14TH MARCH, 1885, No. 613 W., PUBLIC WORKS.

I have the honor to forward, for your countersignature and submission to Government through the Board of Revenue, a revised estimate of Rs. 16,682, accompanied by a comparative statement, for constructing the Head Assistant Collector's cutcherry at Penukonda, in lieu of the estimate of Rs. 12,240 sanctioned in G.O., No. 2900 W., dated 10th October 1882.

Head Assistant Collector's
Cutcherry at Penukonda

Revised estimate for —, sanctioned.

REVISED STAND FOR SUB COLLECTORS' CUTCHERRIES.

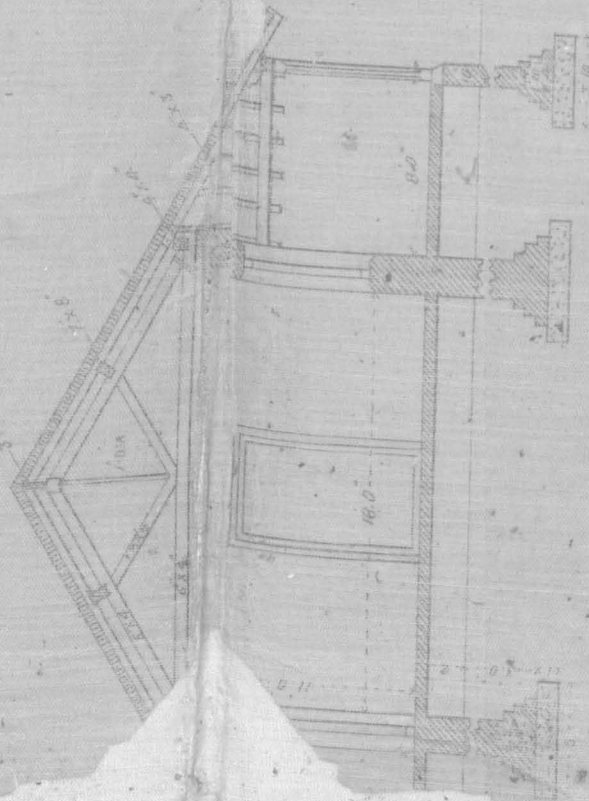
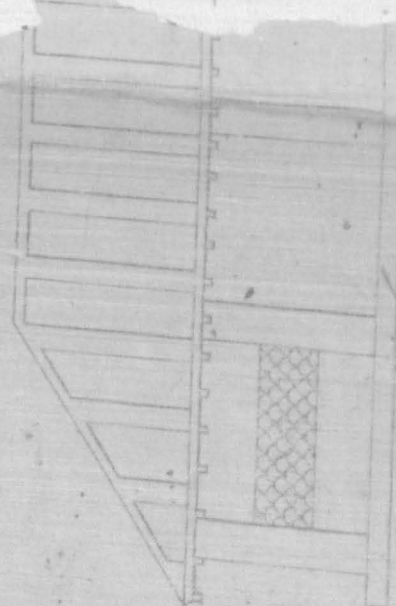
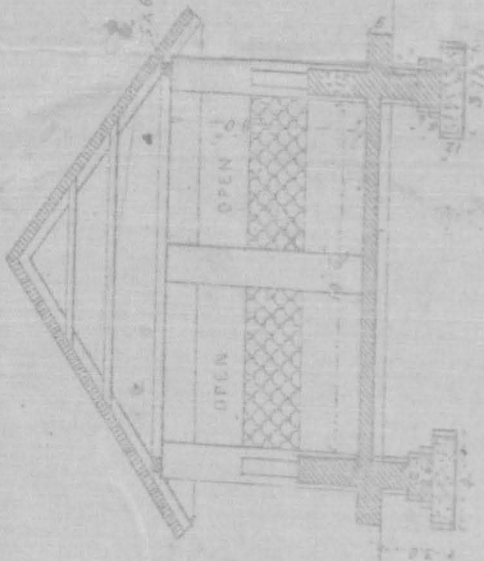
2. Owing to the constant annoyance experienced and expense incurred in connection with the ordinary tiled roofings, it has been deemed advisable to substitute concrete terracing, and this modification was duly approved of by the late Collector, Mr. Roupell.

3. The previous estimate provided for a shed for witnesses; this has been now omitted. There is no need for it, as one already exists within the taluk cutcherry enclosure, not many yards distant from the Assistant Collector's cutcherry site.

4. The standard design approved in G.O. No. 195, dated 29th March 1876, has been followed as far as practicable, but the depth of foundation and basement has been altered to suit local circumstances.

2. The revision consists in the substitution of terrace for tiled roofing for the cutcherry. - S.E. III. assigns the following as the reasons for the proposed change: -

"Tiled Roofing it has been deemed advisable to substitute concrete terracing" It will be seen no special circumstances are adduced which would make tiled roofing particularly objectionable in this individual instance.

of the 29th March/78, have been fairly followed in the revised plan. — The scantings of the roof timbers differ slightly from those laid down in the standard specifications, and, subject to approval, may be accepted.

The Government accept the recommendation of the Superintending Engineer, III Circle, and the Board of Revenue, and sanction the revised estimate, amounting to Rs. 16,682, for constructing a Head Assistant Collector's catcherry at Pennakonda.
